BIRMINGHAM CITY COMMISSION
SPECIAL LAND USE PERMIT AMENDMENT

SUBJECT: **Public Hearing for Final Site Plan & Special Land Use Permit Amendment at 563 & 575 S. Eton – Griffin Claw Brewery**

SUBJECT: **563 & 575 S. Eton — Final Site Plan Review/SLUP Amendment - Griffin Claw Brewing Co.**

SP-101

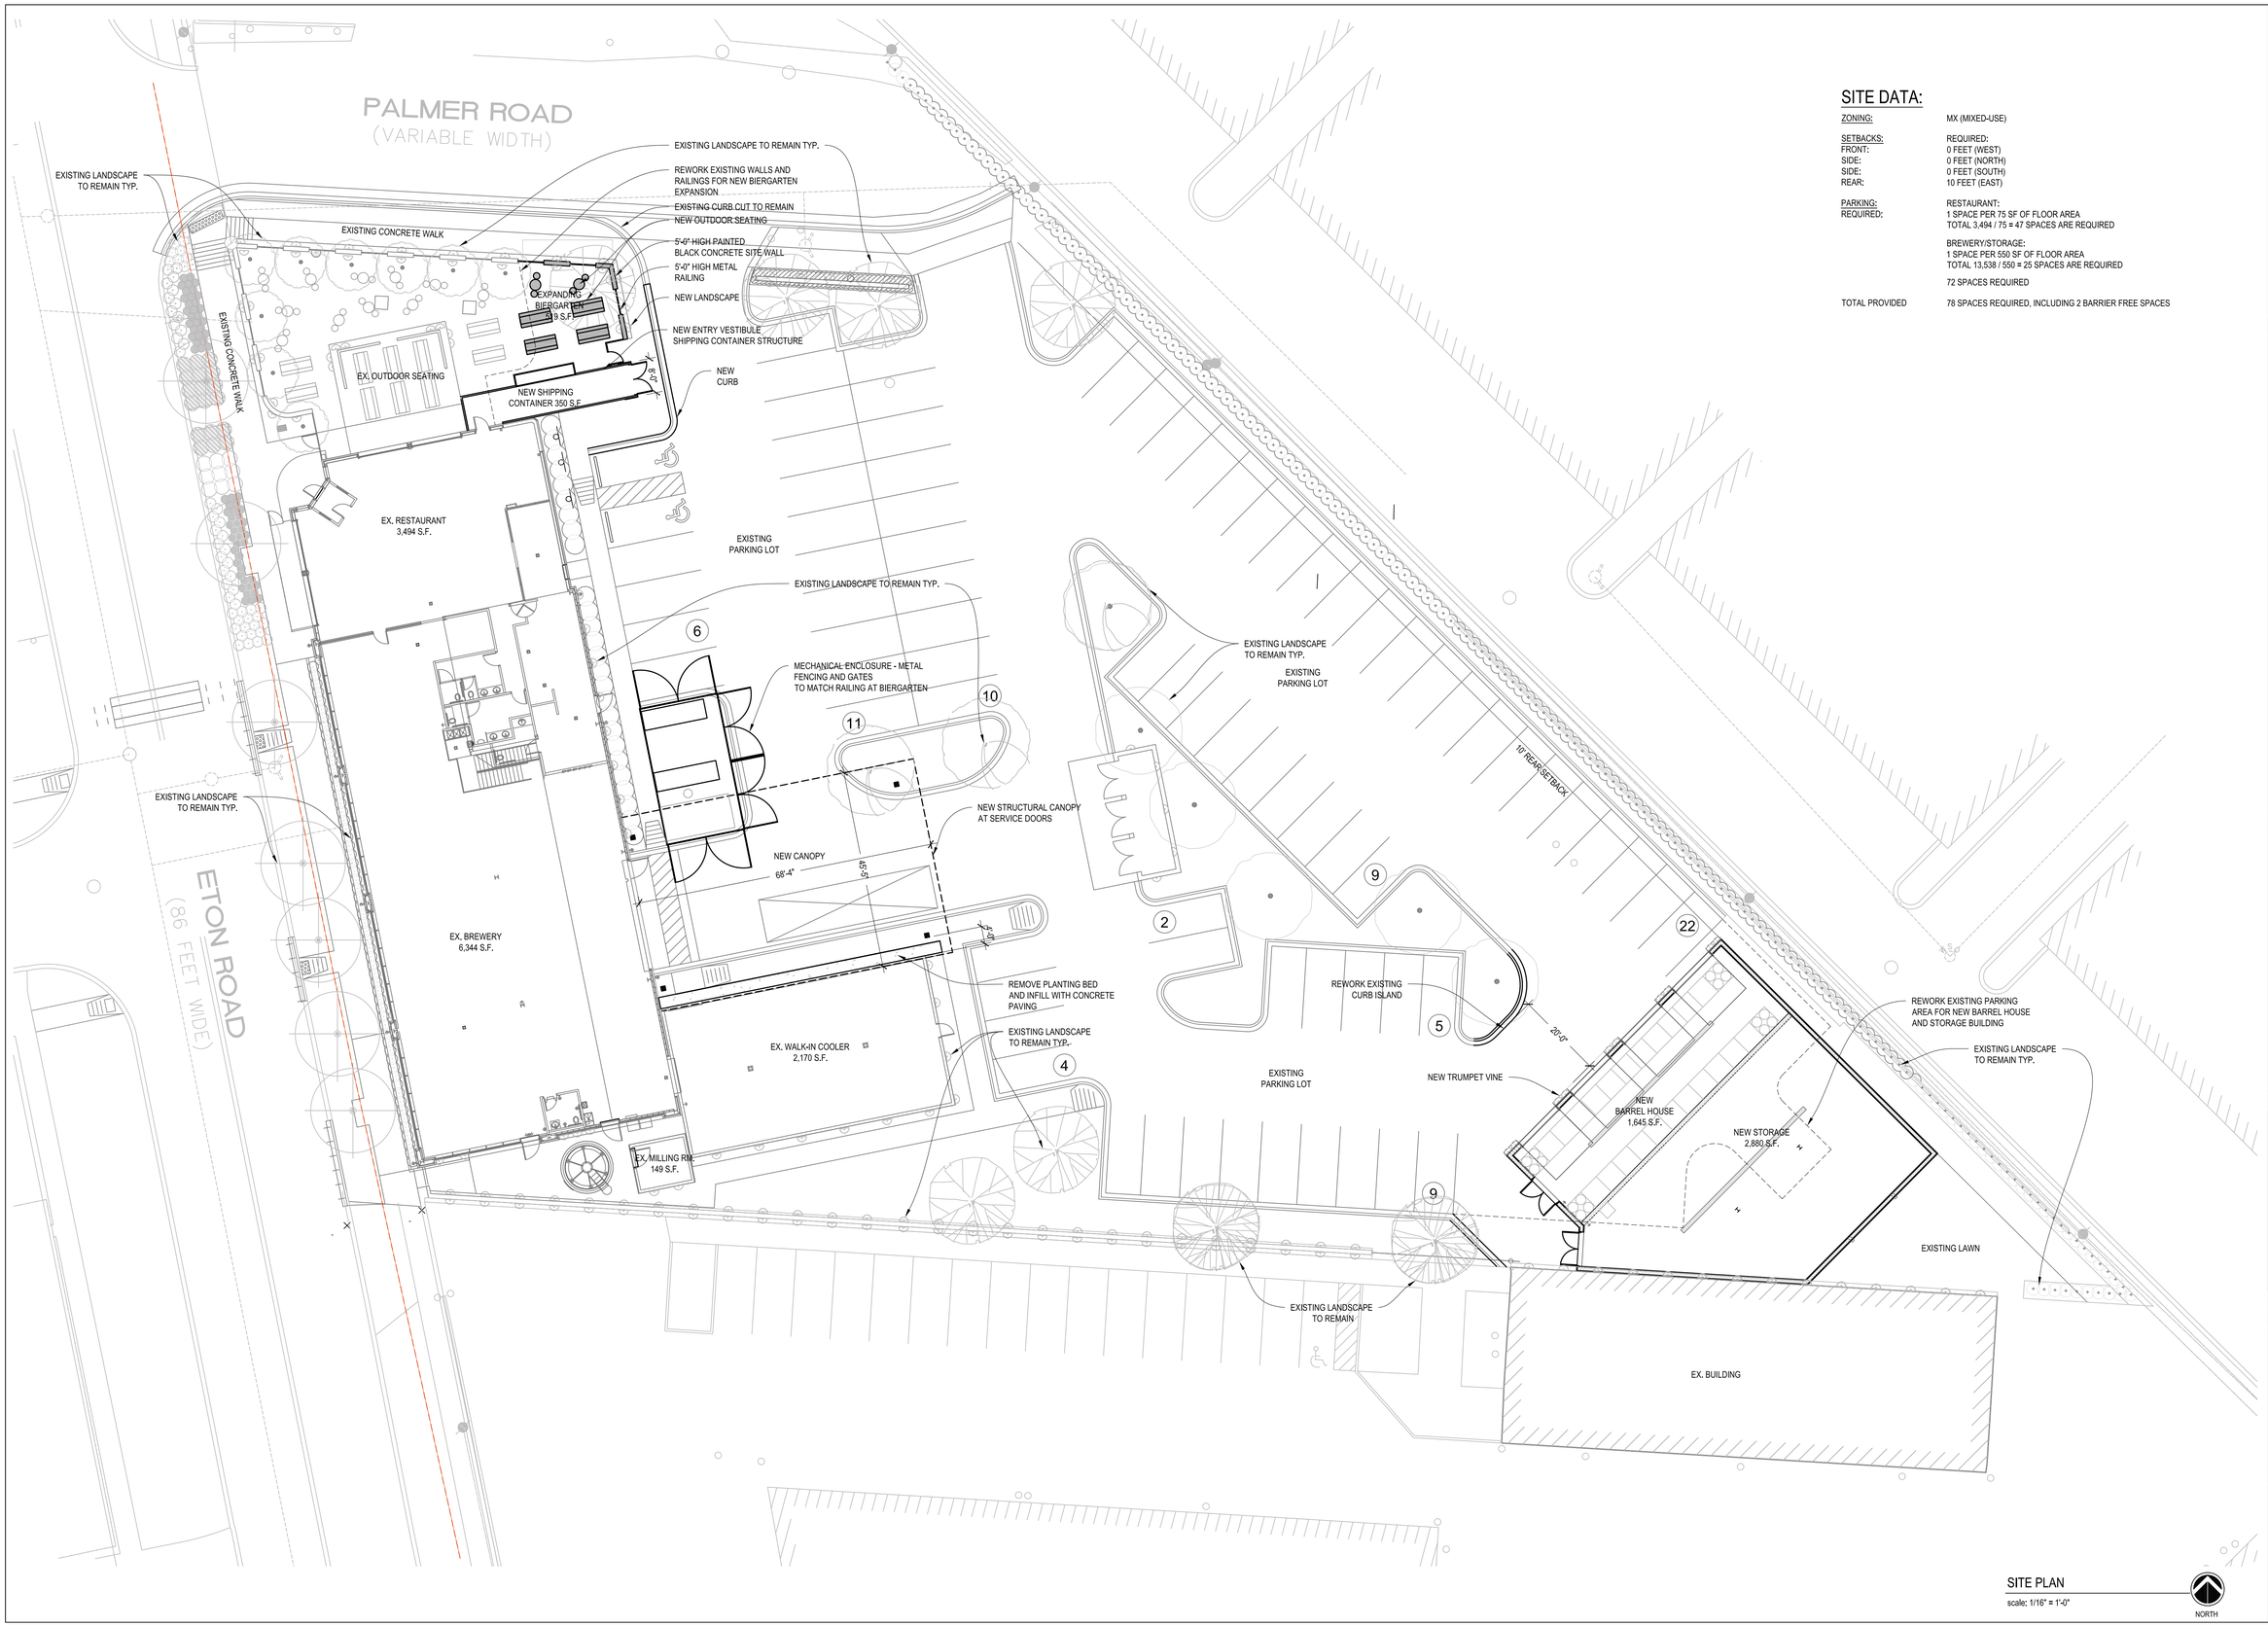
1) The applicant complies with the comments/suggestions made by the various departments and addresses the width of the parking lot access lane in front of the barrel house, subject to administrative approval.

Chairman Clein said that considering the number of vehicles in the parking lot he is bothered by the 16 ft. 7 in. wide drive aisle. He received confirmation that the height of the canopy works at 17 ft.

The applicant has submitted revised plans that comply with the conditions of the Planning Boards recommendation by expanding the drive aisle in front of the barrel house from 16' 5.5" to 20'.
